**Public Hearing for an Amendment to the
Planned Unit Development (PUD) – Lot
14A and 15A Southport East Replat Eight
and Lots 1-4 Southport East Replat Nine –
The Lund Company**

RECOMMENDATION REPORT

CASE NUMBER: PPUD-17-0004

RE: Proposed Securities American Expansion & Offsite Parking Lot Facility
Amendments to PUD Plans-Ordinances 1020 and 1045

Sheet Name
Emergency Vehicle
Access Plan

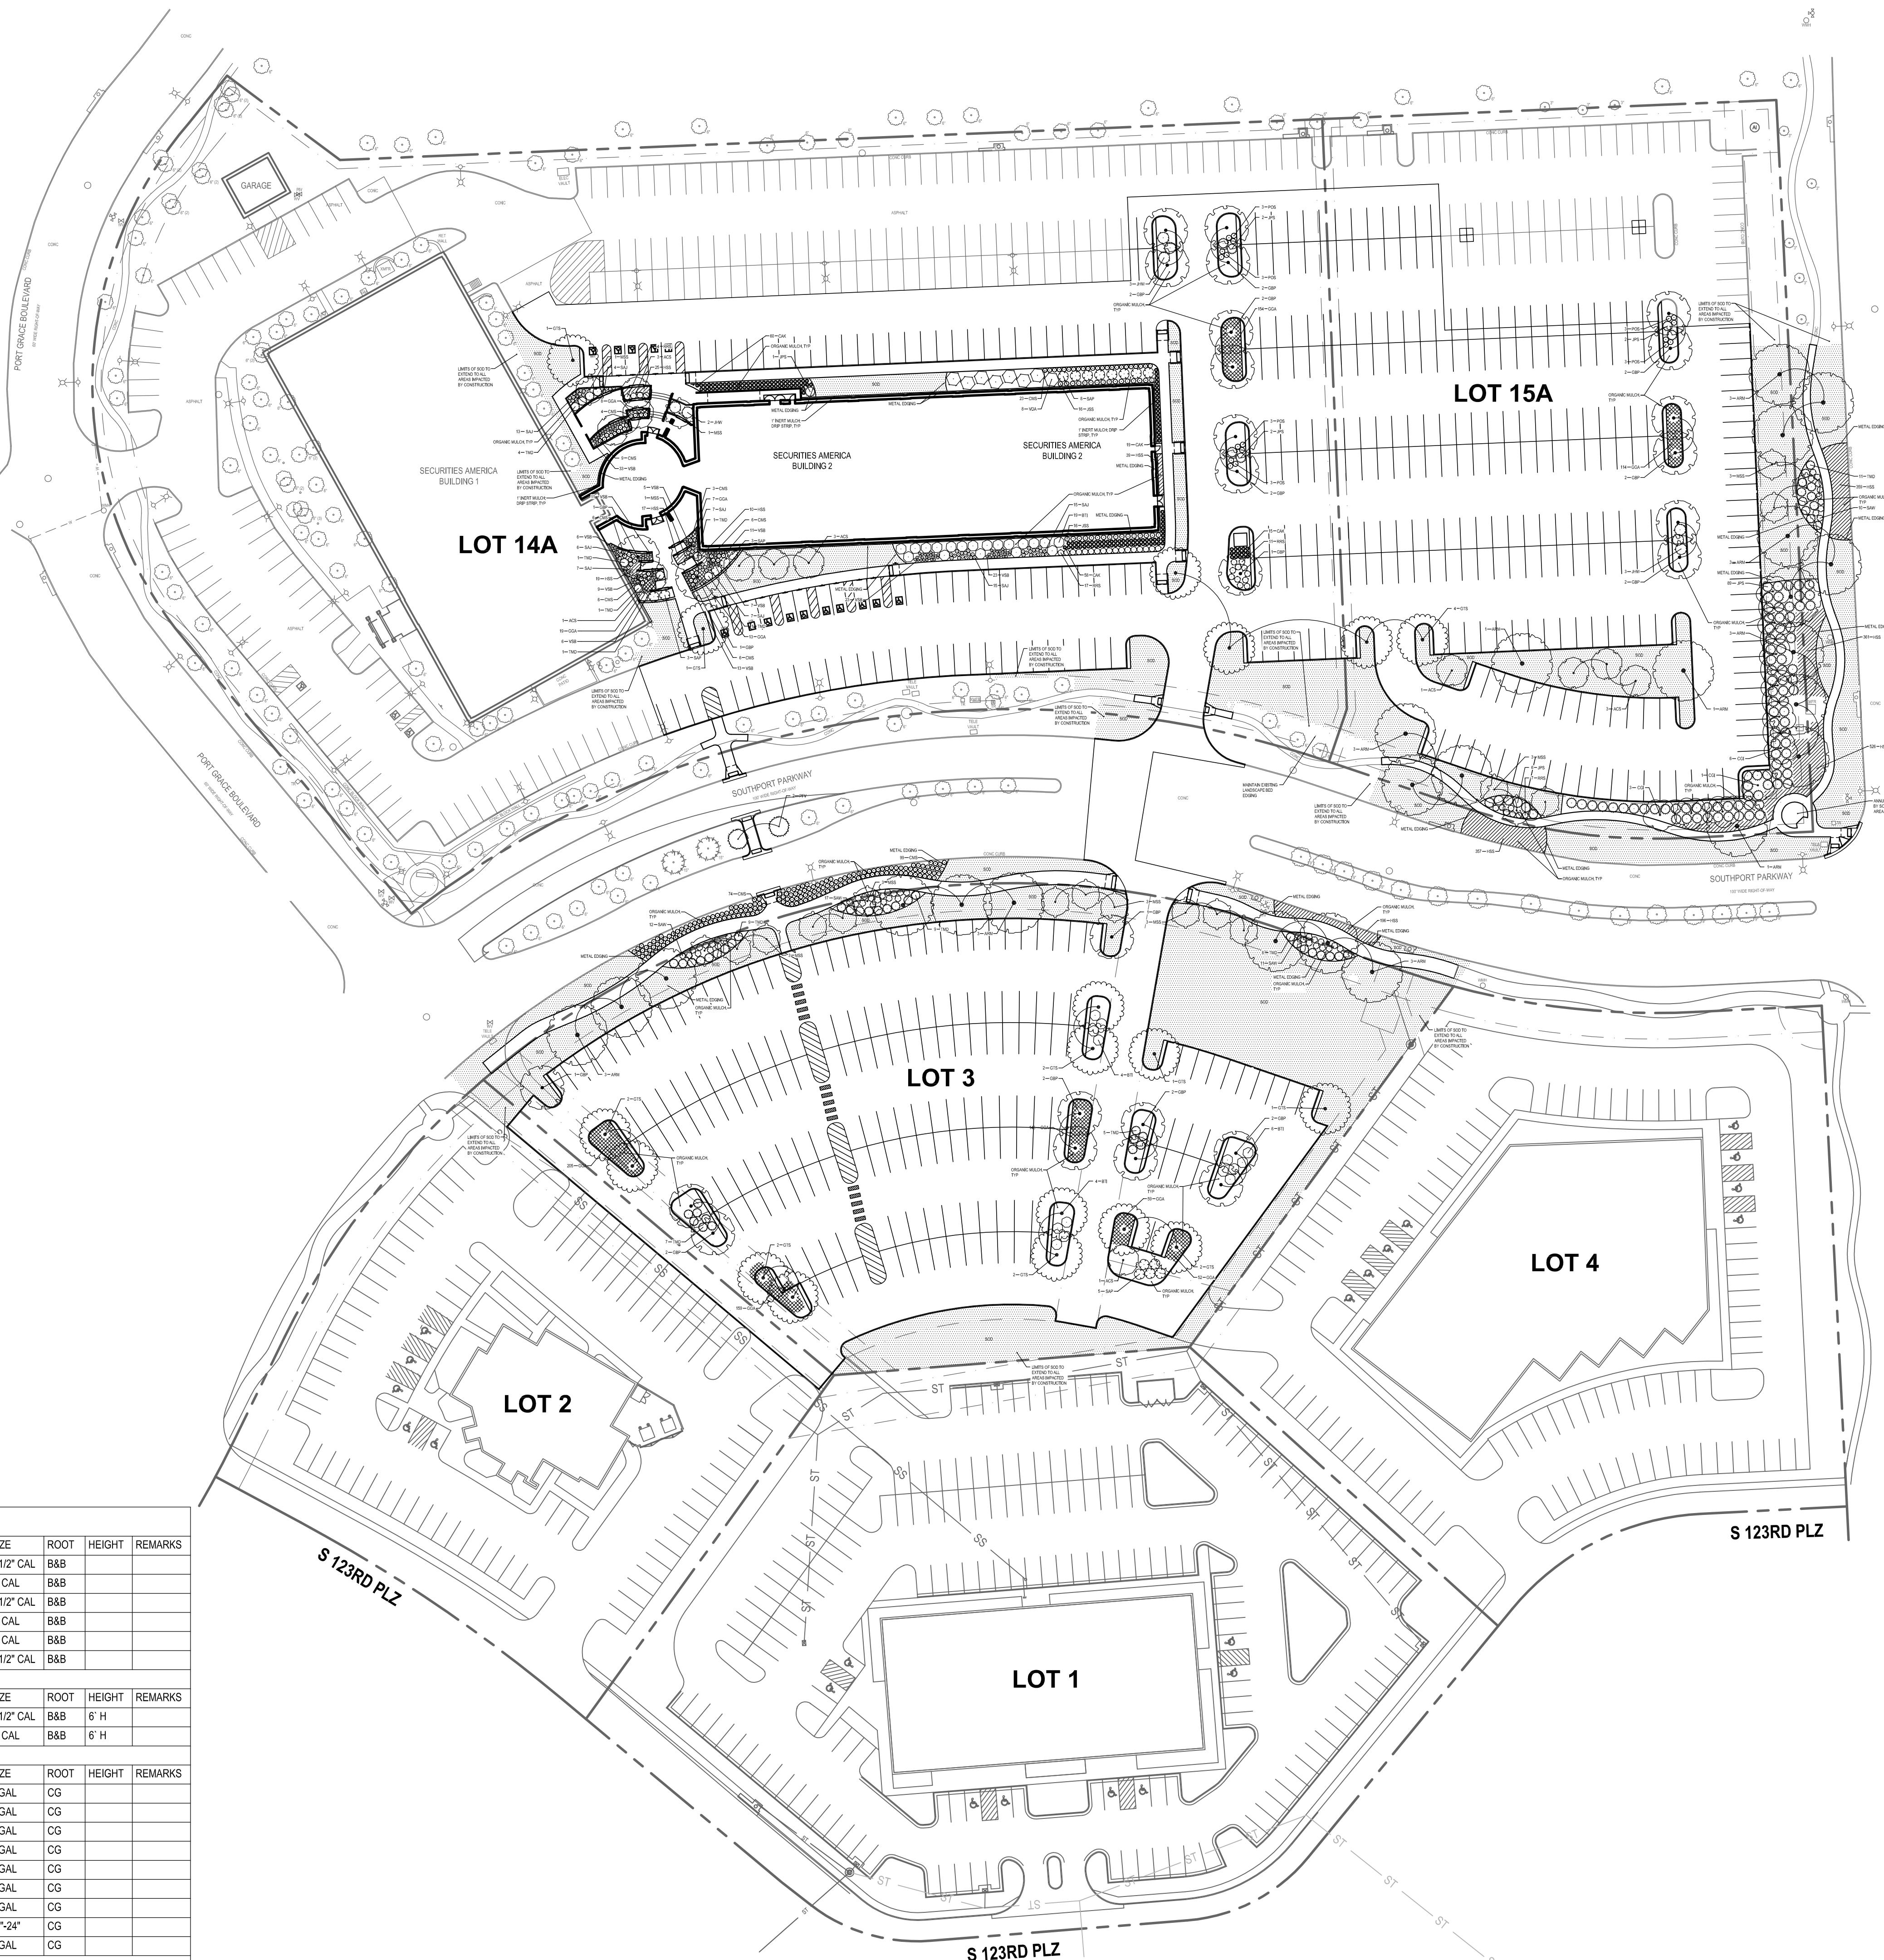
4. Article 5.15.04.04: Exhibit "E" has been provided to the Fire Marshall for review and comment. Comments are expected within the next 24-48 hours and will be forwarded upon receipt.

See revised Emergency Vehicle Access Plan - Exhibit E.

4. Article 5.15.04.04: Exhibit "E" has been provided to the Fire Marshall for review and comment. Comments are expected within the next 24-48 hours and will be forwarded upon receipt. **See Note 8 on Exhibit A.**
